1	A	ISSUED FOR ADDENDUM 1	2018/12/04
0		ISSUED FOR TENDER	2018/06/27
Revisions/		Description/Description	Date/Date
Client/client

Project title/Titre du projet
SANDSPIT, B.C.
TRANSPORT CANADA
SANDSPIT AIRPORT
LIGHTING UPGRADE

Drawing title/Titre du dessin
COMBINED SERVICES BUILDING
UPPER FLOOR PLAN
LIGHTING RENOVATION

Project No./No. du projet R.089425.001	Sheet/Feuille E303 11 of 18	Revision no. 1
---	--	-----------------------------

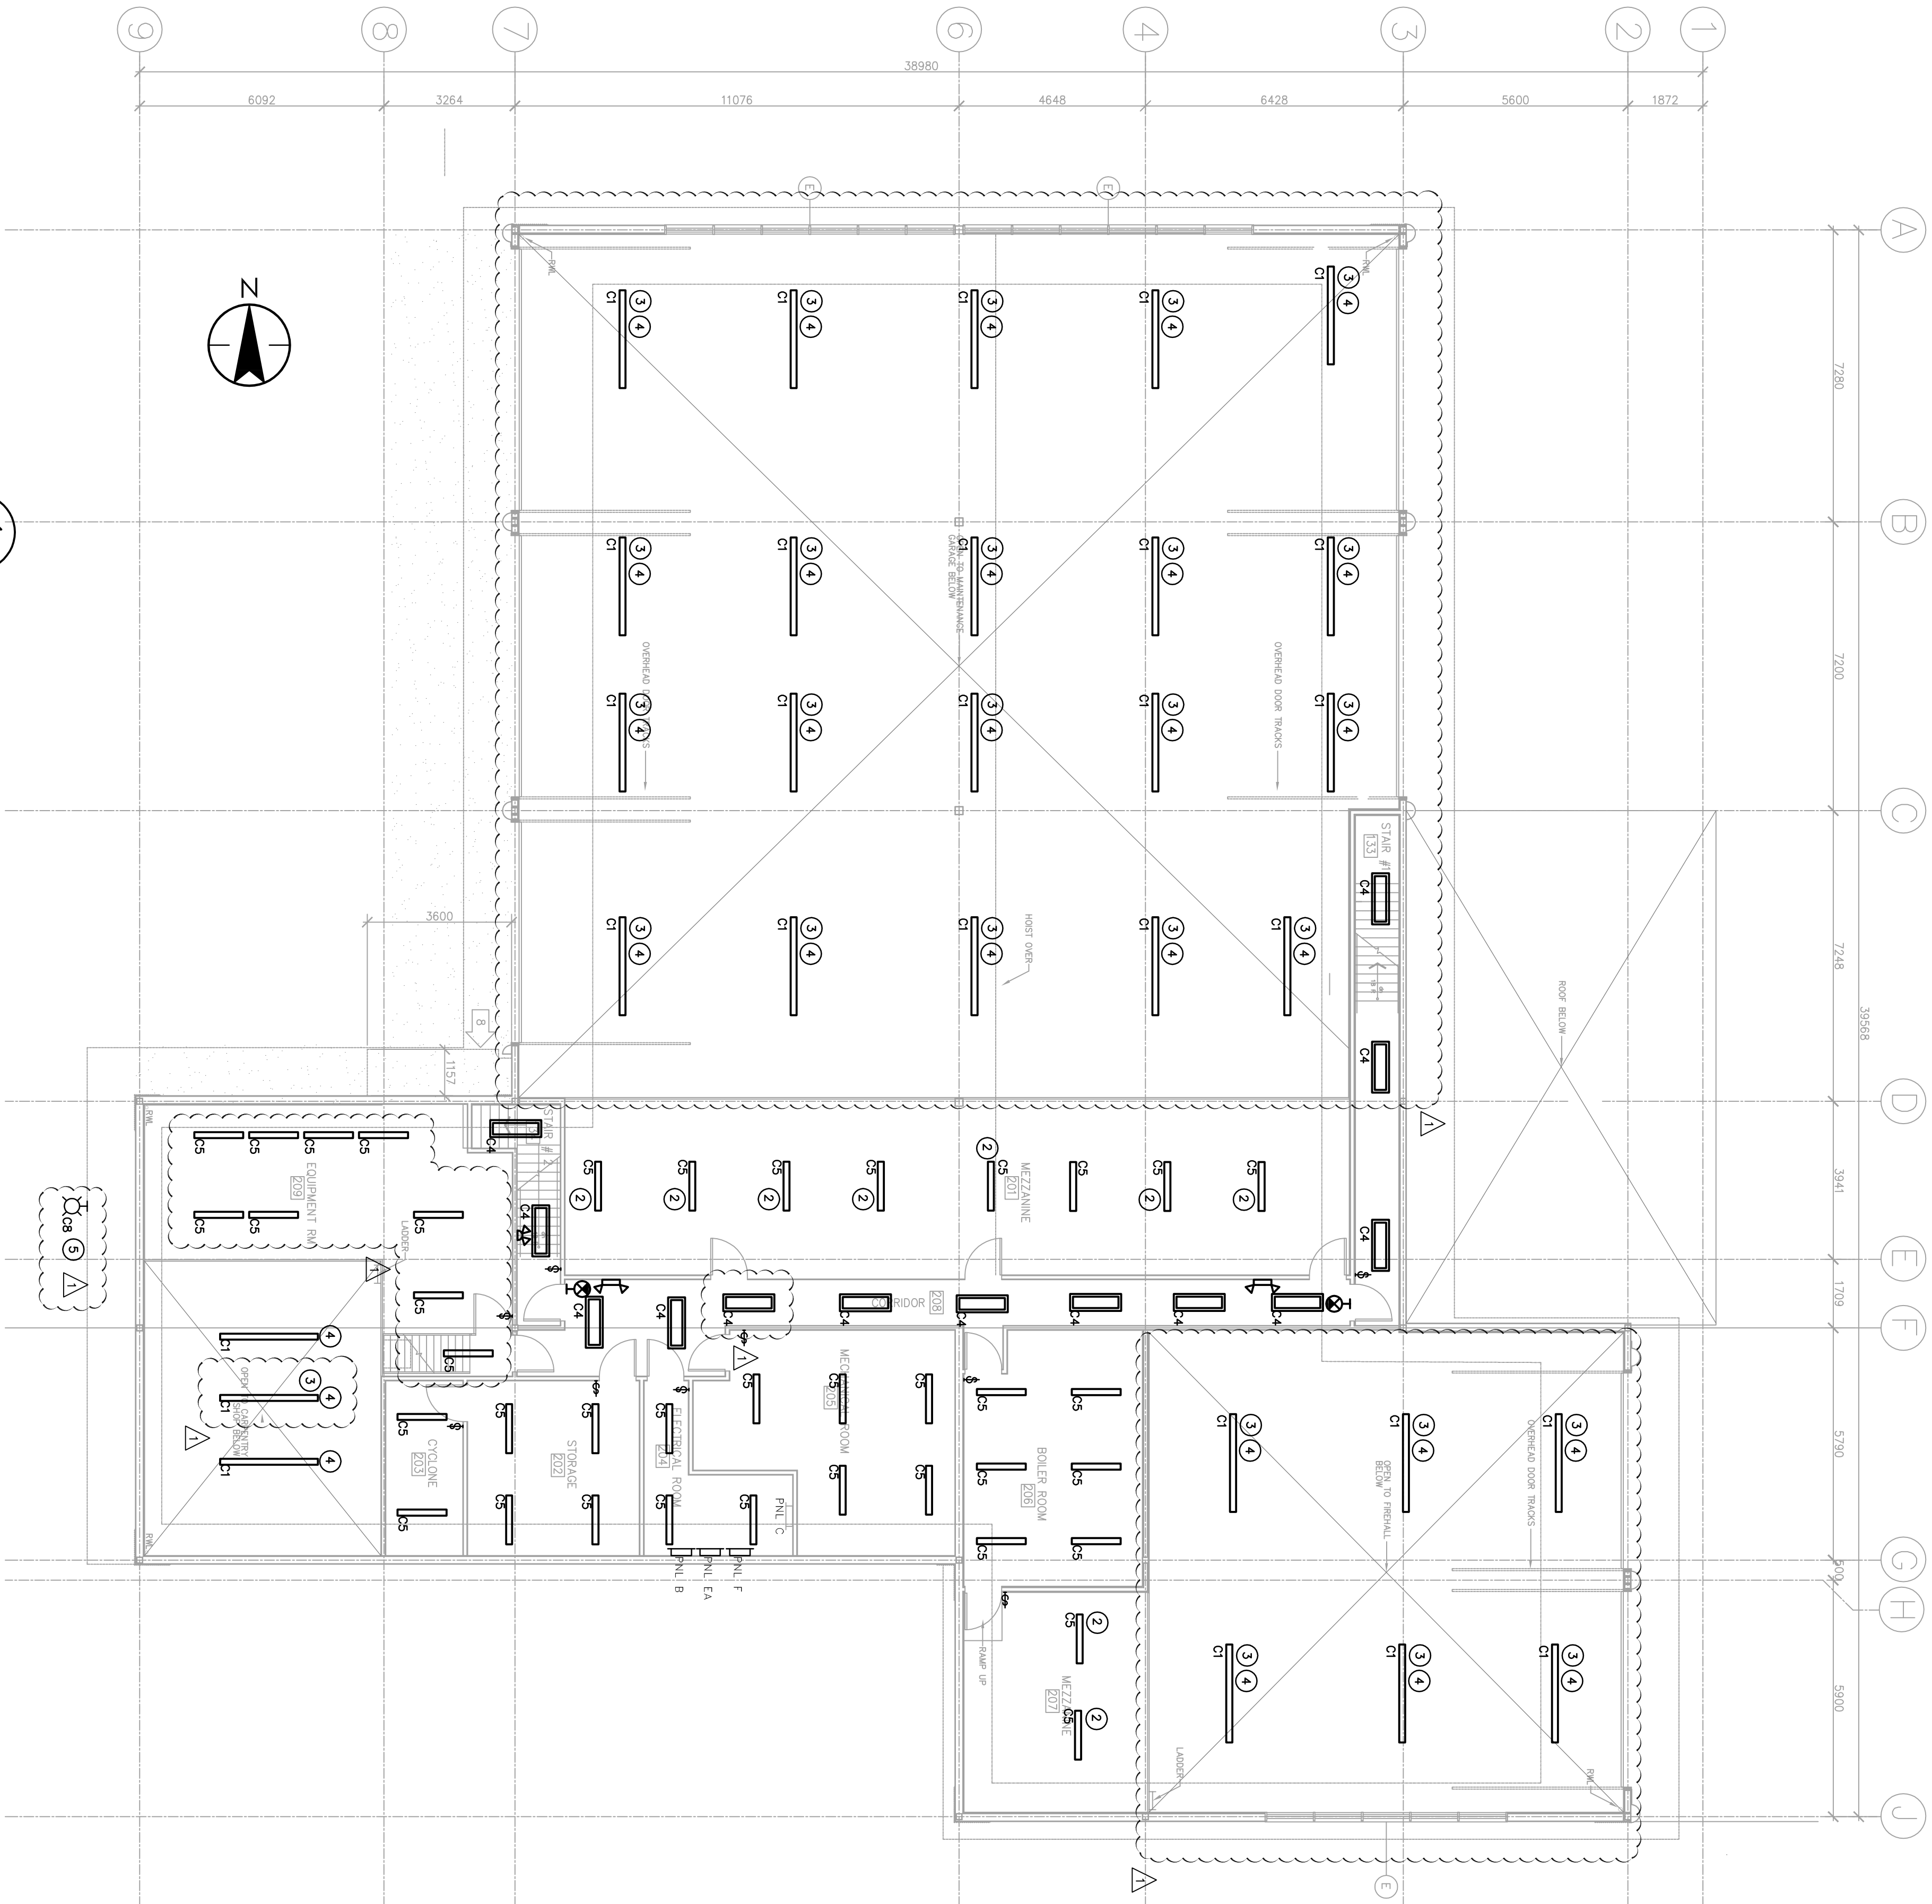
NO LONGER USED.
- 2

NEW LUMINAIRE IN NEW LOCATION - EXTEND EXISTING WIRING FROM ADJACENT LUMINAIRE BEING REMOVED.
- 3

EXTEND EXISTING AREA LIGHTING CONDUIT AND WIRING SYSTEM TO NEW LUMINAIRE LOCATION FOR 120V CONNECTION.
- 4

NEW LINEAR LED FIXTURE TO BE PENDANT MOUNTED, SUSPEND AT THE BOTTOM OF TRUSS LEVEL, CLEAR OF ANY OBSTRUCTION, EXTEND WIRING FROM EXISTING
- 5

NEW TYPE C6 LUMINAIRE TO REPLACE EXISTING LUMINAIRE, SUSPEND AT THE BOTTOM OF TRUSS LEVEL, CLEAR OF WALL, PROVIDE COVER FOR EXISTING BOX AND EXTEND WIRING IN NEW SURFACE MOUNT ROSSGROM FROM TOP OF UPPER WALL PORTION REFER TO PHOTO H ON E304.
